RE: Penrith City Park, Penrith – Traffic Management Advice

This Transport Statement (TS) provides our initial design advice and comments in relation to Council's draft concept plan issued to Ason Group via email of 6 May 2020 and shown in **Figure 2** and subsequent changes that have been agreed to.

**Figure 2: Proposed Draft Concept Design by Penrith City Council**

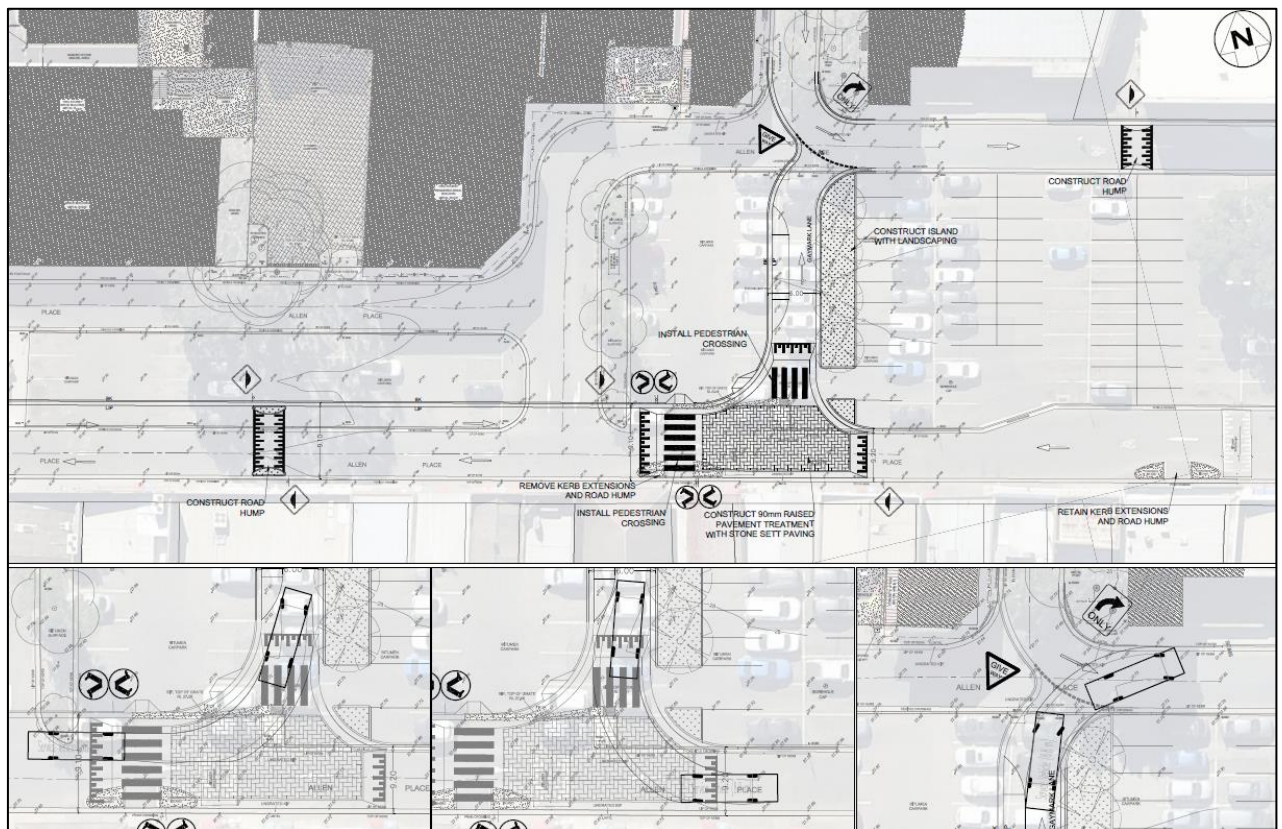
Pedestrian (zebra) crossings are proposed as part of Council's concept plan, at the newly formed intersection of Allen Place and Gaymark Lane. It is proposed to install a zebra crossing on Gaymark Lane and another on Allen Place (western leg). It is important to note however, that Transport for New South Wales (TfNSW) specify warrants in the Supplement Australian Standard 1742.10-2009, Manual of Uniform Traffic Control Devices – Part 10: Pedestrian control and protection (Version 3.1) which need to be satisfied prior to installation of zebra crossings.

Whilst pedestrian flow data is not available, and is expected to change as a result of the development of the Penrith City Park, the vehicle flows are expected to fall below and not meet the warrants which requires PV to be greater than or equal to 60,000 in each of three separate one hour periods in a typical day; therefore, TfNSW may not approve the proposed pedestrian crossings.

With consideration to the above, the requirements for a Special Warrant can be satisfied quantitatively. Furthermore, Council are required to justify the reasoning behind the special consideration for this location. In this regard, the construction of a new recreational park should serve as an acceptable justification.

The provision of a zebra crossing and wombat crossing is therefore supportable from a traffic perspective, further to the justification for a Special Warrant from Council.

Figure 3: Updated Design – 28 August 2021

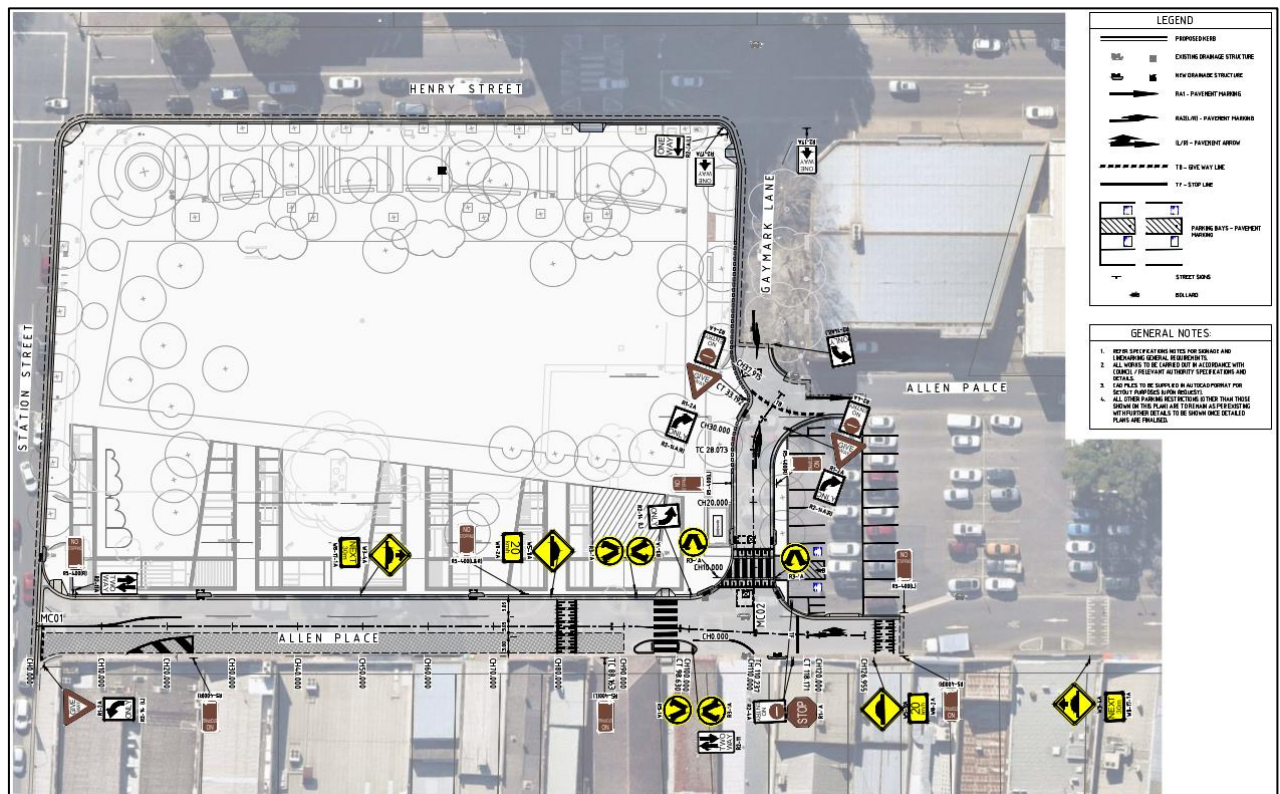
Furthermore, an updated plan was submitted to Ason Group via email on 28 August 2021, shown in **Figure 3**. This TS also provides design advice based on this latest design.

As per the updated plan, a typical width of 9.1m would be provided for Allen Place comprising two travel lanes and one parking lane and a typical width of 6.1m for the new one-way northbound street, comprising a travel lane and a drop-off / pick-up lane. The proposed widths have been assessed against the requirements set out in Table C10.1 of Council's DCP, replicated below for reference:

Based on the controls stipulated in Council's DCP, both Allen Place and Gaymark Lane would fall under the category of a 'Local Road' which is defined as *a road or street used primarily for property access. Local roads include laneways, access ways and rural residential roads for lots typically less than or equal to 1 hectare.* With consideration to Table C10.1, the proposed widths are consistent with the requirements of Council's DCP.

Furthermore, having consideration for the traffic volume data provided by Council, which indicates that these streets accommodate relatively low volumes of traffic, the proposed widths are compliant with Austroads *Guide to Road Design – Part 3: Geometric Design*, which recommends widths of 3.0m – 3.3 metres per travel lane in low-speed urban environments with low truck movements (as is assumed to be the case).

Therefore, the proposed road widths of Allen Place and Gaymark Lane are supportable from a geometric design perspective. Moreover, there is opportunity to investigate the provision of other facilities such as bicycle lanes.

With consideration to the above, refer to Figure 3 for the signage plan which presents the locations of all traffic management devices and signs.
